## MOD5 SSD7348

### Response to Council submission on MOD5 - SSD7348, dated 9 September 2020

## PLAN OF SUBDIVISION OF LOT 8 IN DP 1261030

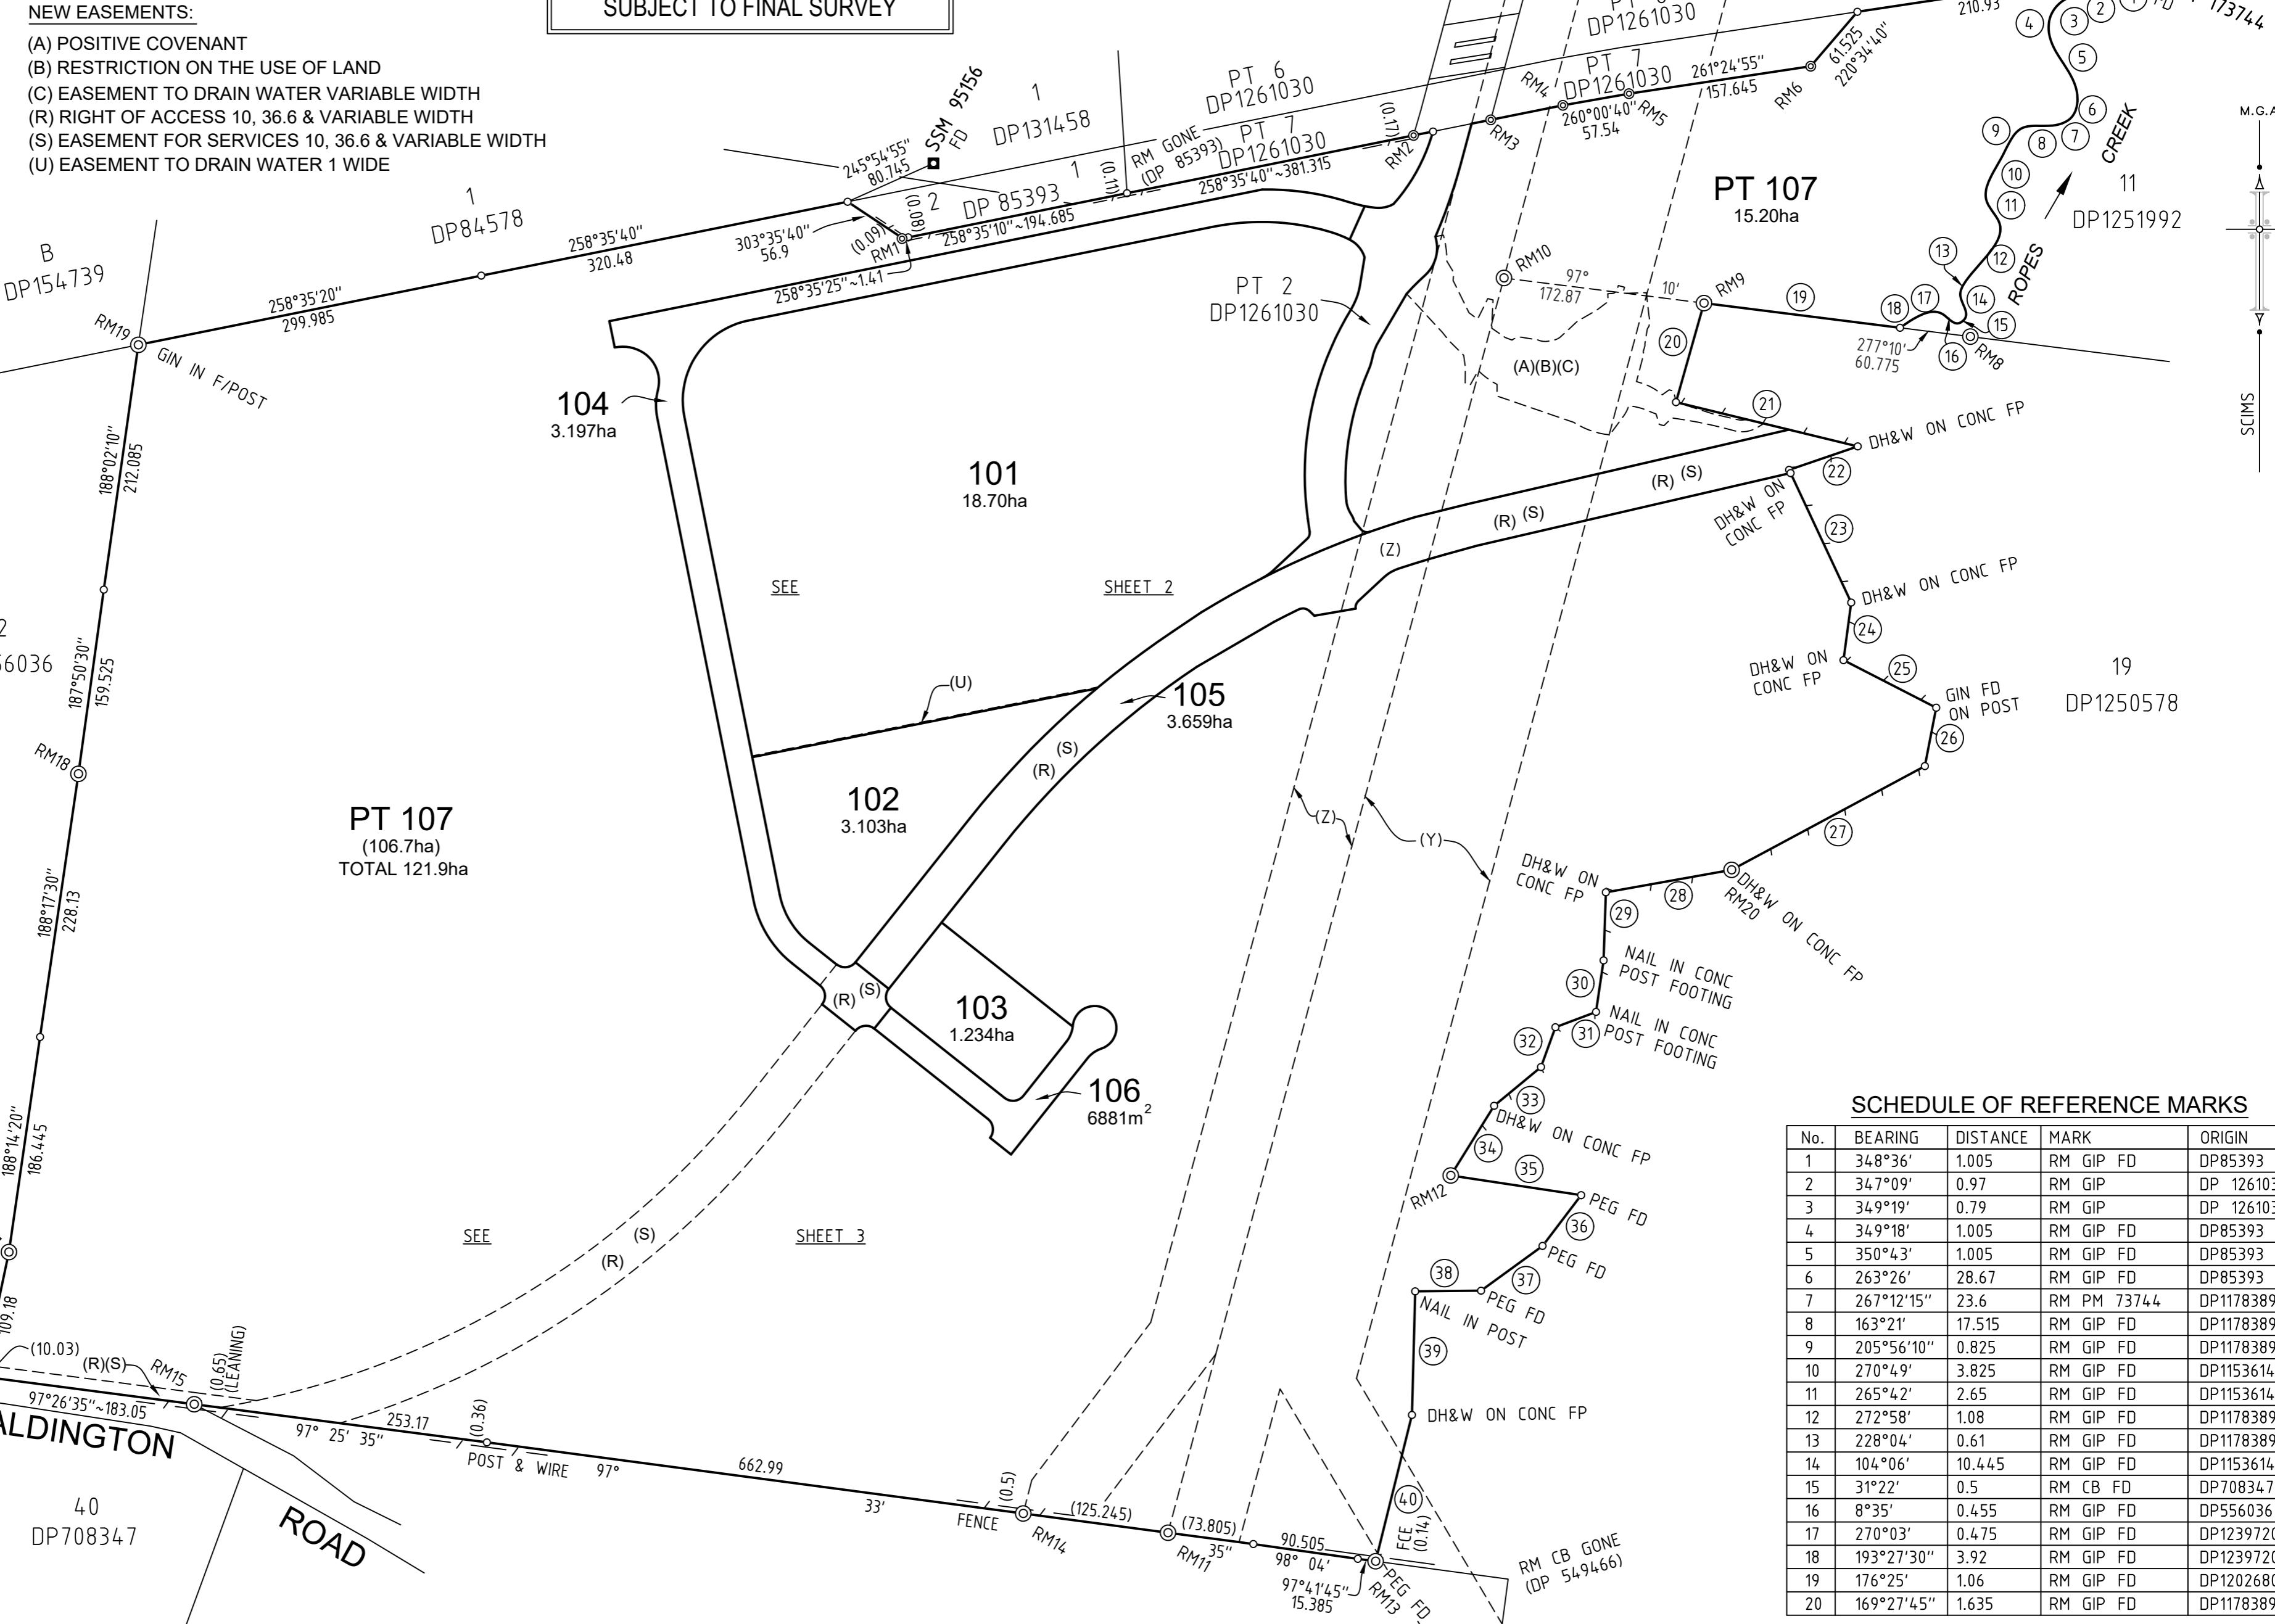
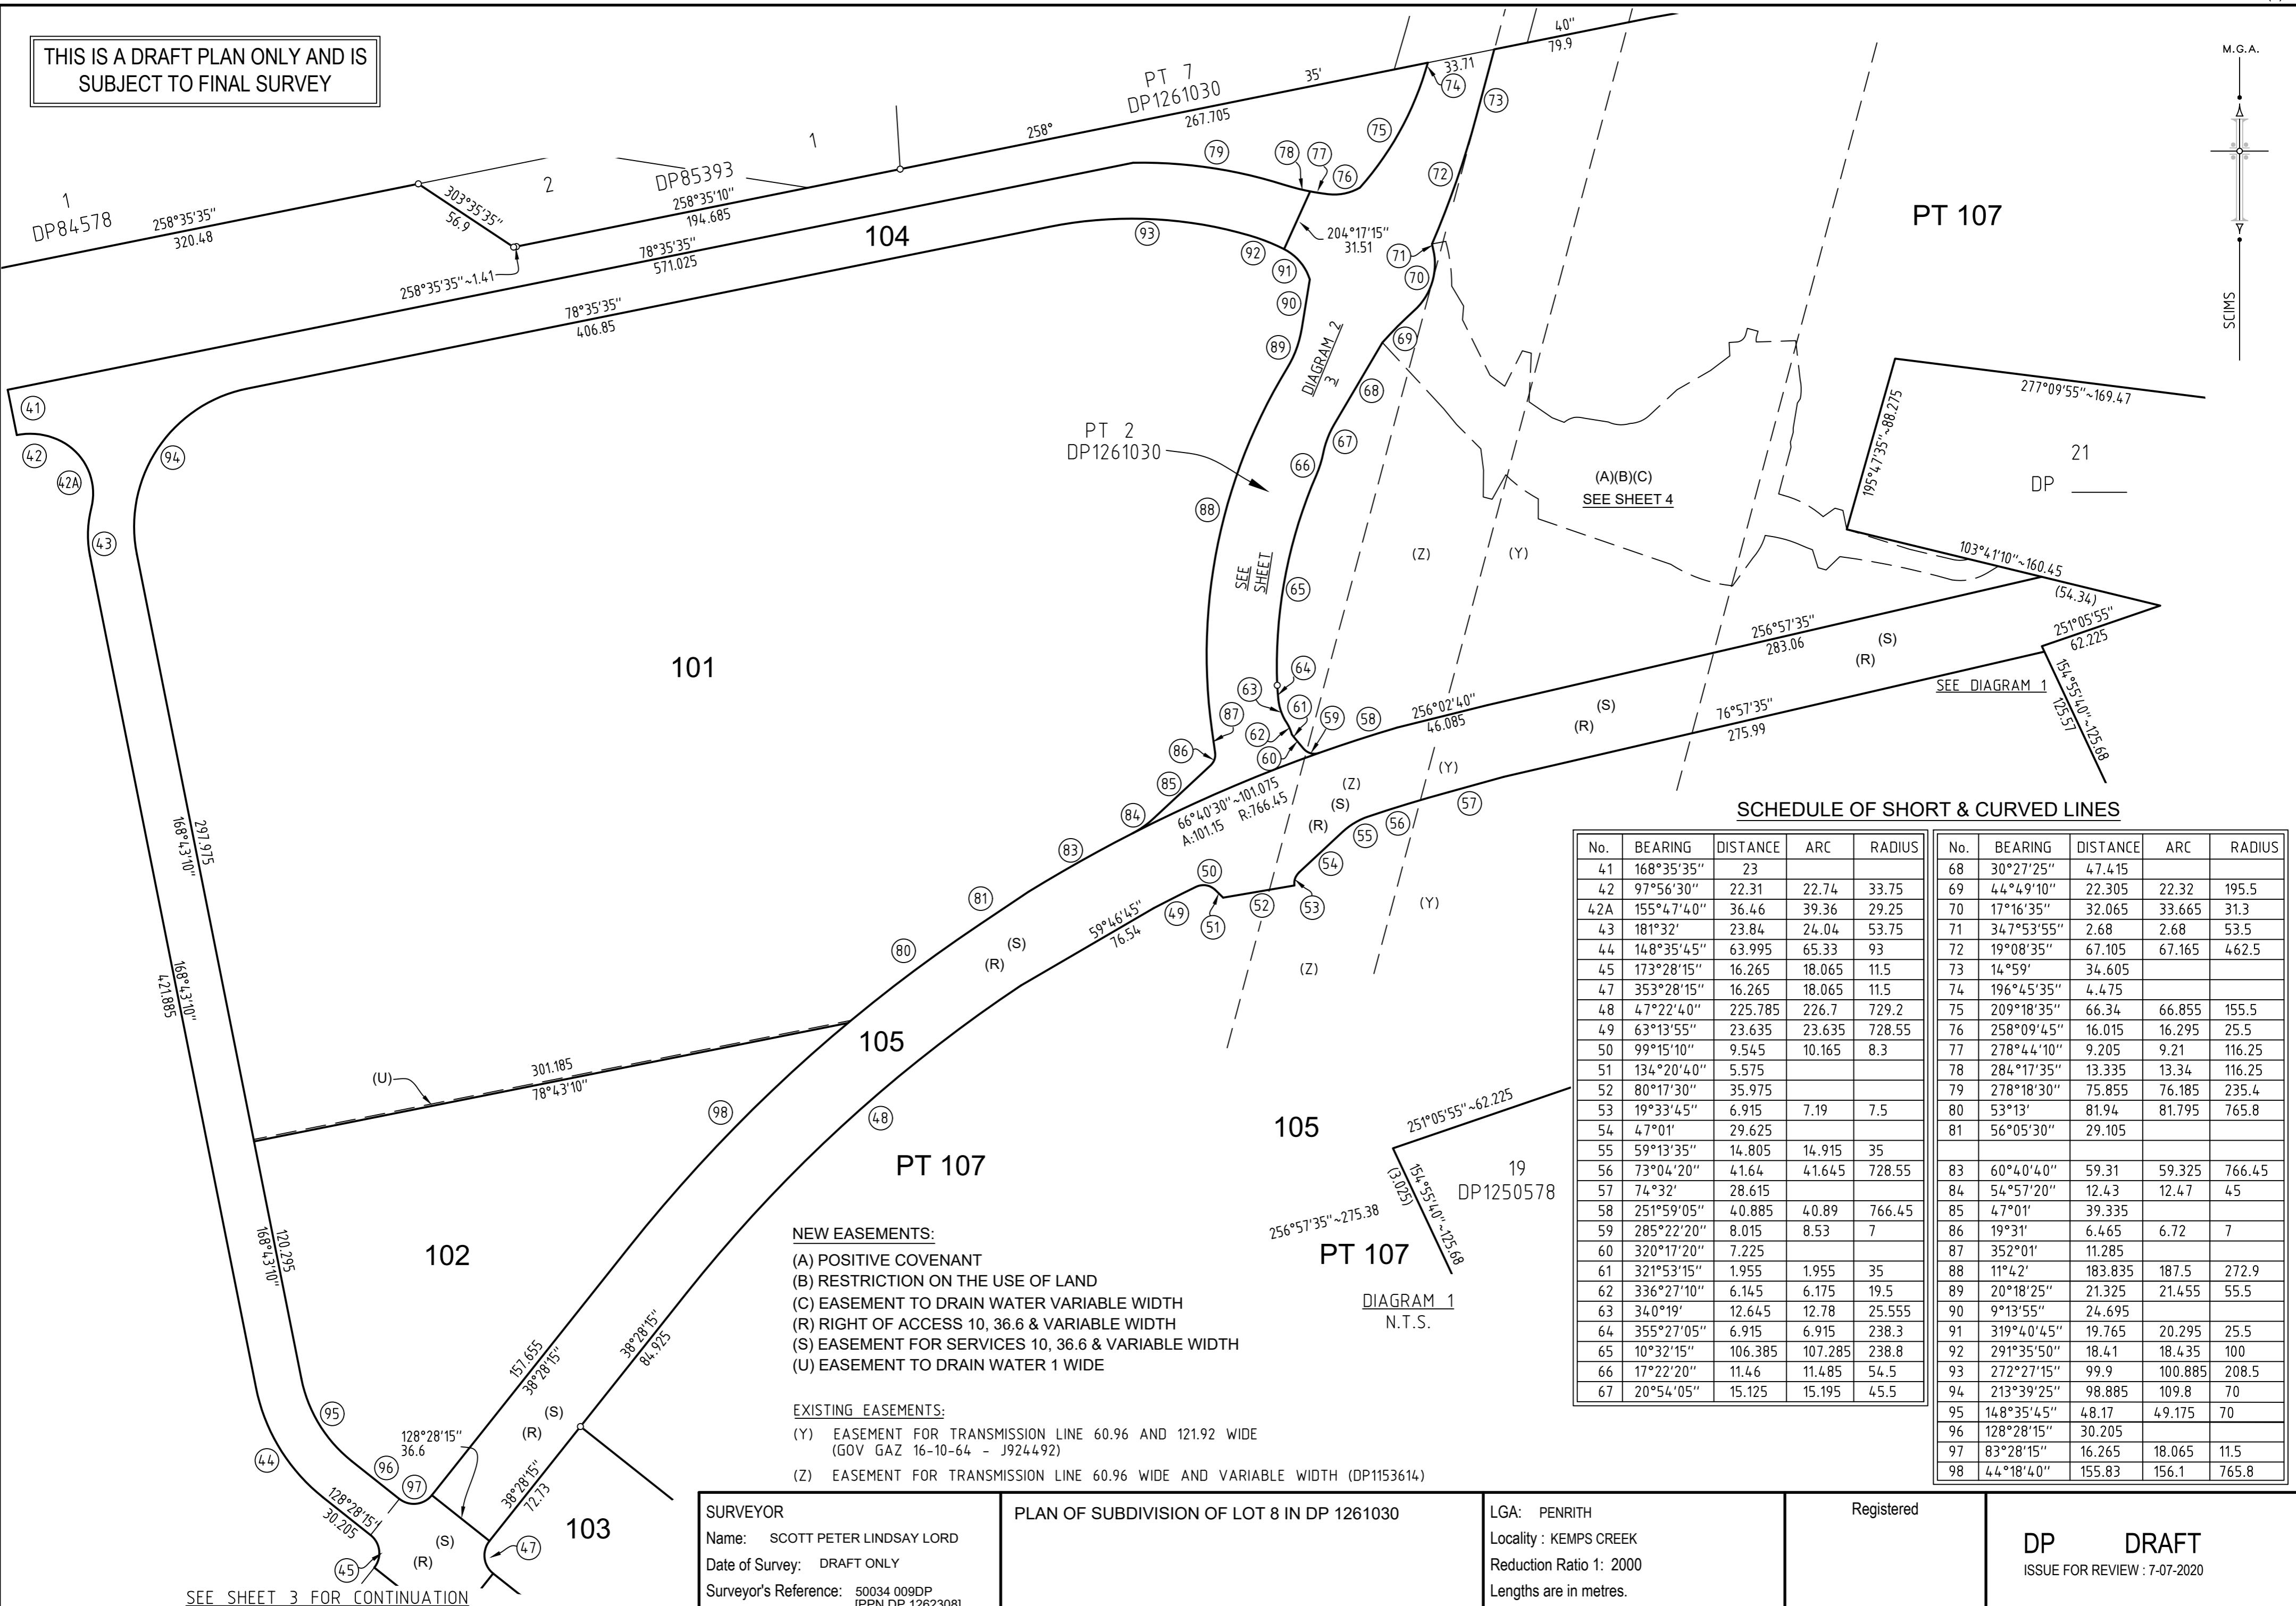
Correspondence has been recently received from TFNSW (dated 10 August 2020) that confirms that the width of the proposed southern link road allotment (proposed lot 105) is insufficient and cannot accommodate the necessary lanes required.	<ul style="list-style-type: none"><li>Goodman have responded to TrfNSW's request to increase the width of the Southern Link Road to 36.6m. Updated subdivision plans can be found within <b>Annexure B</b>.</li><li>TrfNSW has since confirmed acceptance of the subdivision plans. Refer to <b>Annexure A</b>.</li></ul>
The plans as submitted with that application have sought to widen the road reserve width beyond what was suggested in the above SSD determination, and TFNSW have now advised of further changes that are required to the proposed plans of subdivision to further widen proposed lot 105 (link road lot) to accommodate the link road intersection design requirements.	<ul style="list-style-type: none"><li>As above. The updated width of the road reserve, as requested by TfNSW, has been included in both the SSD7348 MOD5 and DA19.0575 plans.</li></ul>

As discussed, land required for Southern Link Road (SLR) does not align with the land identified in the proposed subdivision plan. The land requirement for the SLR would be a combination of purple and red line boundaries shown on the attached plan. The proposed subdivision is generally along the purple line boundary.

Please submit updated subdivision plans showing area bounded by the red line to Council for referral to TfNSW. Identification of this land on the subdivision plan is required to ensure that structures, buildings or utilities are not allowed within this land.

TfNSW Comment	Goodman Response
<b>Planning, Engineering and Landscaping Matters</b>	
The proposed Modification No. 5 to SSD Determination No. 7348 seeks to respond to an unapproved subdivision arrangement that is the subject of a current development application with Council which as yet, is not supportable by Transport for NSW (TFNSW). The assessment and determination of this separate subdivision application is dependant on endorsement of the proposed lot creation and resulting road reserve widths which have not been accepted by TFNSW.	<ul style="list-style-type: none"><li>Subdivision approval has been granted by DPIE as part of the initial SSD 7348 consent and SSD 7348 MOD 2 consent;</li><li>Goodman had lodged DA19.0575 with Council on 23 August 2019 which was prior to determination of SSD 7348 MOD 2;</li><li>Both subdivision plans have now been endorsed by TrfNSW (per <b>Annexure A</b>), albeit with proposed conditions. The latest subdivision plans that accommodate TrfNSW's comments can be found in <b>Annexure B</b>.</li></ul>

We refer to the below email, and our call this morning and confirm our discussions that TrfNSW are satisfied with the updates Goodman have made to the subdivision plan that reflect the 36.6m Southern Link Road (SLR) corridor.
